**DOCUMENT 00901
ADDENDUM NUMBER 02**

DATE: June 28, 2010
PROJECT: Cashier Counter Upgrade
For Water Utilities Department
101 West Abram Street, Arlington, Texas
PROJECT NUMBER: WUD-0901
OWNER: City of Arlington
ARCHITECT: City of Arlington
101 W. Abram Street, Arlington, Texas
Ph: (817) 459-6550
TO: Prospective Bidders

5 CAB. SECTION AT CASHIER
 SCALE: 1" = 1'-0"

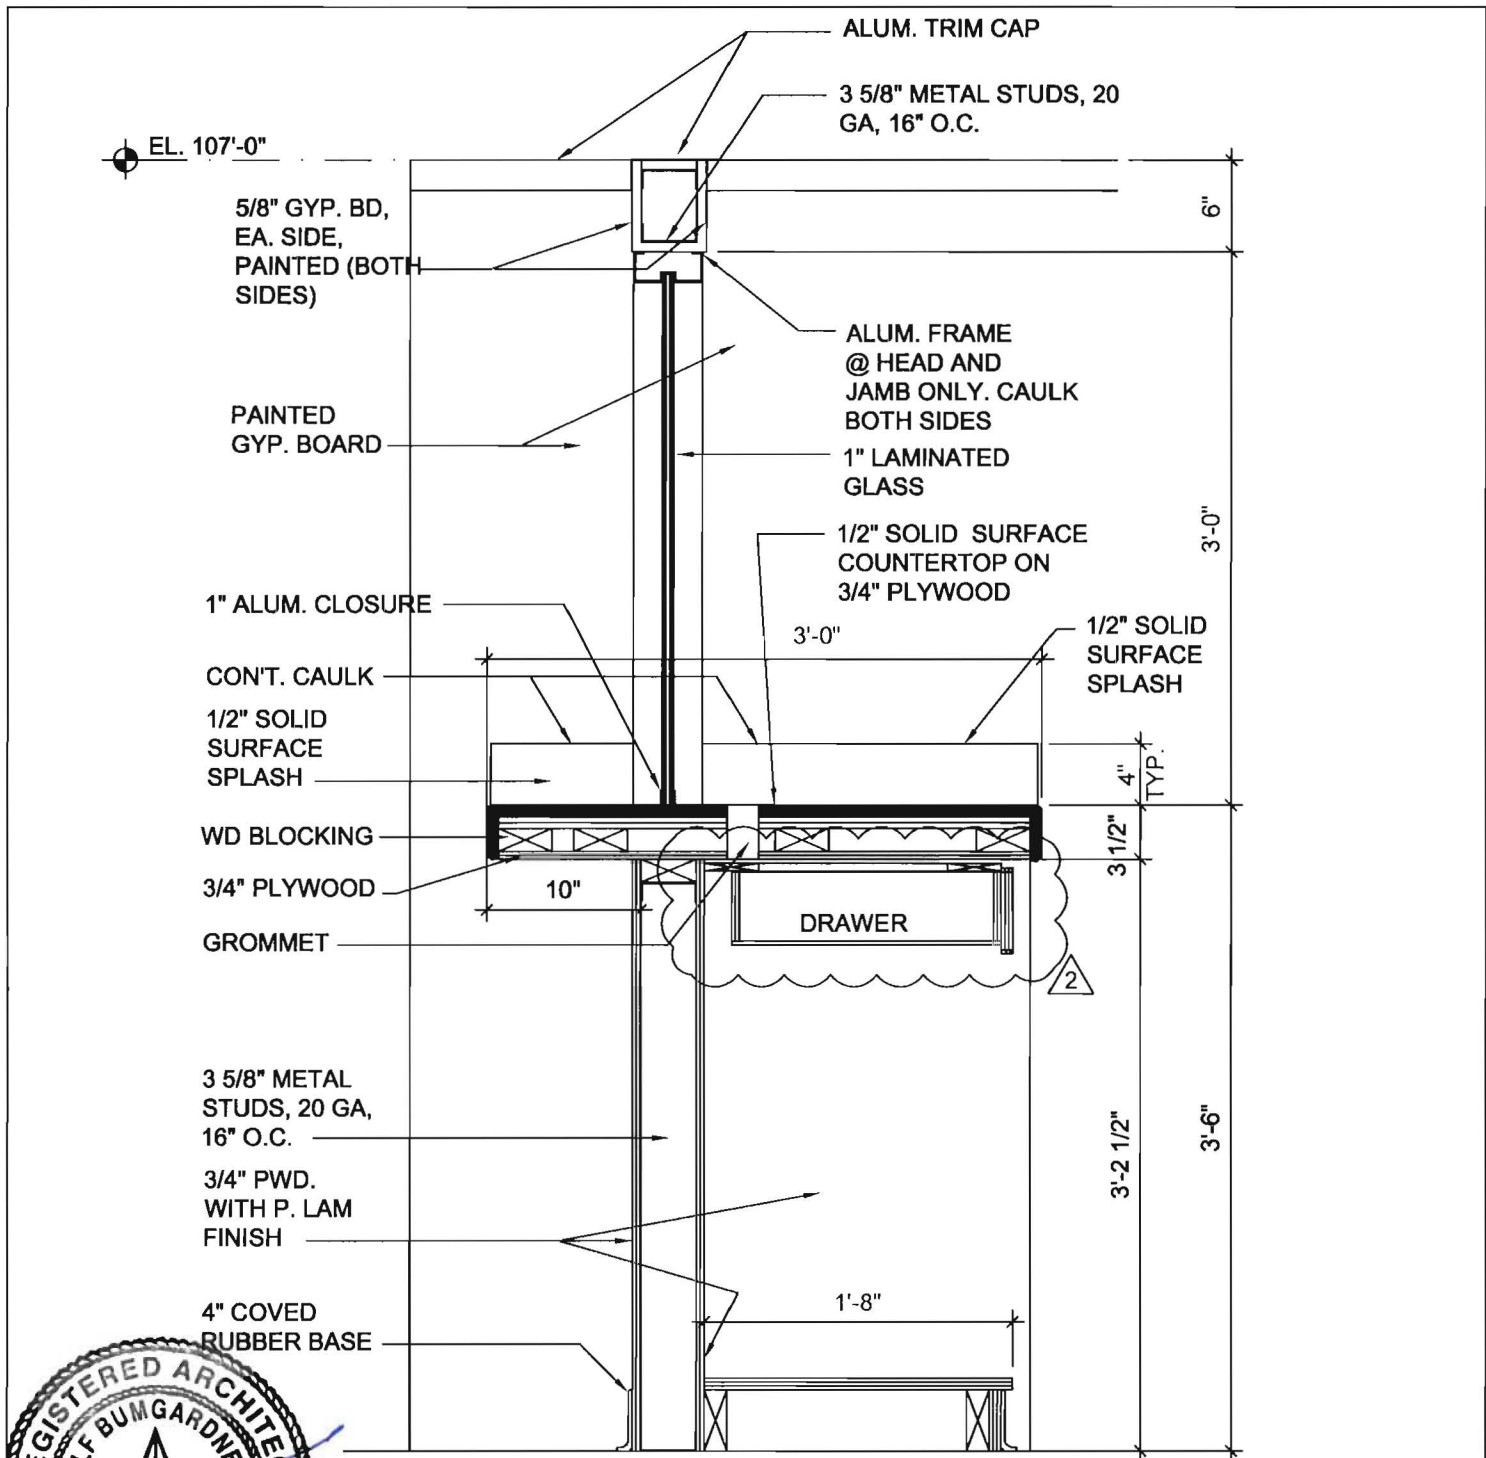
- c. Refer to attached sheet SDA2.0 for revised detail 5.
- 5. **Sheet E1.00 – Partial Floor Plan - Power Demolition**
 - a. The data and telephone outlets next to the removed power receptacle should be removed as well.
- 6. **Sheet E1.01 – Partial Floor Plan – Power**
 - a. Power & Receptacle note 8 is not used.
